City of El Paso – City Plan Commission Staff Report

Case No: SUSU12-00063 Butterfield Trail Industrial Park Unit Three
Replat A

Application Type: Resubdivision Combination

ATTACHMENT 6

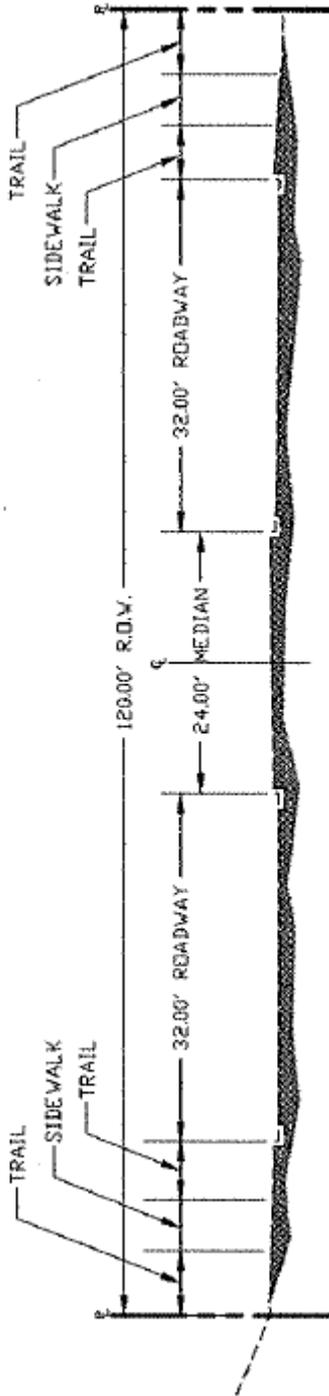
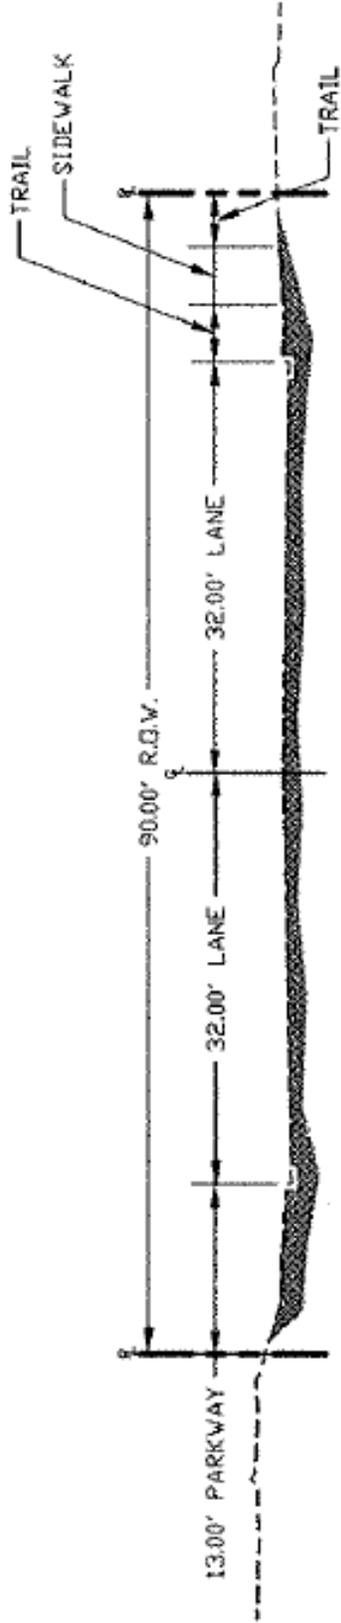
Per Section 19.26.040, the applicant is requesting an alternative subdivision improvement design for the rights-of-way, specifically regarding the design of a trail within the parkway (Attachment

No sidewalks exist in the area and no connectivity presently exists in the industrial park at all. The compacted-screenings sidewalk is not an inferior improvement to a concrete sidewalk for various reasons. In fact the compacted-screenings sidewalk (i.e., trail) reduces impact stress upon walkers and runners alike. The section of the compacted-screenings sidewalk has an improved drainage ability that will permeate storm water rather than shed it to the street, thus partially reducing the potential storm water pollution. There is also a reduction of the Urban Heat Island Effect of the compacted-screenings versus the concrete. This would make the compacted-screenings sidewalk a more eco-rational solution as opposed to concrete. The compacted-screenings sidewalk is a better than or equal to sidewalk solution than concrete. As such we recommend the alternative design.

Please find attached a detail of the cross-section of the proposed trail detail in lieu of the required concrete walkway. The trail, as shown, fully complies with the Americans with Disabilities Act and the Texas Accessibility Standards. We respectfully request that the City Planning Commission (CPC) consider a modification of materials for this small section of the replat.

Approval with alternative subdivision improvement design. In this case, the design has been coordinated with City of El Paso Engineering staff and has been determined to meet or exceed standards within the Design Standards for Construction manual.
